# MIPS R4000PC/SC Errata, Processor Revision 2.2 and 3.0

May 10, 1994

Note: Change bars in the left column indicate corrections or changes from the last revision of the errata.

Figure 1a: Power-on Reset or Cold Reset - Workaround for Bug# 54

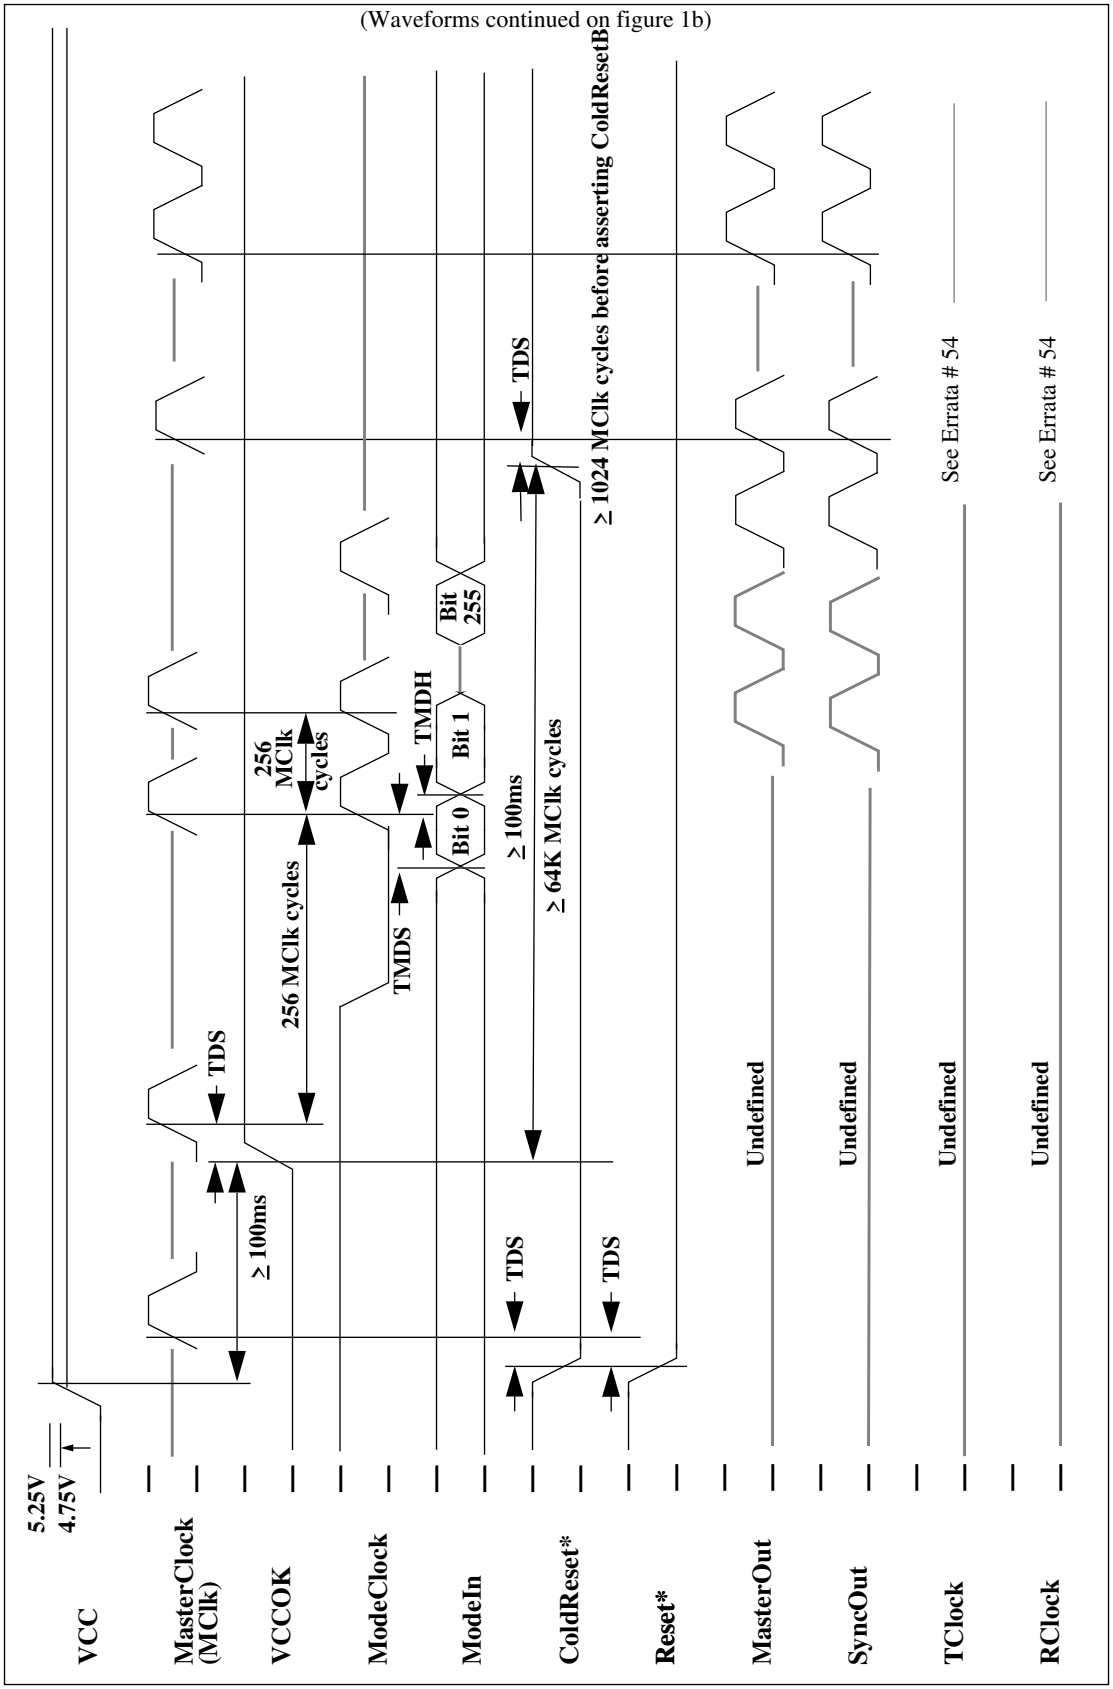
**54.** R4000PC, R4000SC: During the power up sequence, the period of TClk and RClk may not be as expected for at least 1024 MasterClock cycles following the de-assertion of ColdResetB. The above bug is true for all system interface divisors. Furthermore, if the system interface divisor other than 2 (i.e. 3,4,6 & 8) is used, TClk and RClk's rising edge may not align to the rising edge of the MasterClock, as specified.

This may not be a problem for systems using only TClk for the external logic. However, certain systems like -

1) systems using MasterClock for the external logic
2) system with external PLL which needs to lock with the internal PLL
3) systems with multiple processors operating in lock-step

this bug may cause problems.

Thus, for system with interface divisor set to two, the only violation will be that the TClk and RClk's period might not be valid within 64 MasterClock after the ColdResetB is de-asserted.

**Workaround:** Assert a second ColdResetB after at least 1024 MasterClock cycles from the de-assertion of the first ColdResetB. ResetB should remain asserted until at least 64 Master-Clock cycles following the de-assertion of the second ColdResetB. TClk and RClk will then be valid 64 MasterClock cycles after the de-assertion of the second ColdResetB and their edge alignment with respect to MasterClock will be as specified. Figure 1a & 1b show the waveforms in more detail. Note that the waveforms in Figure 1b are continuation of the those in figure 1a.
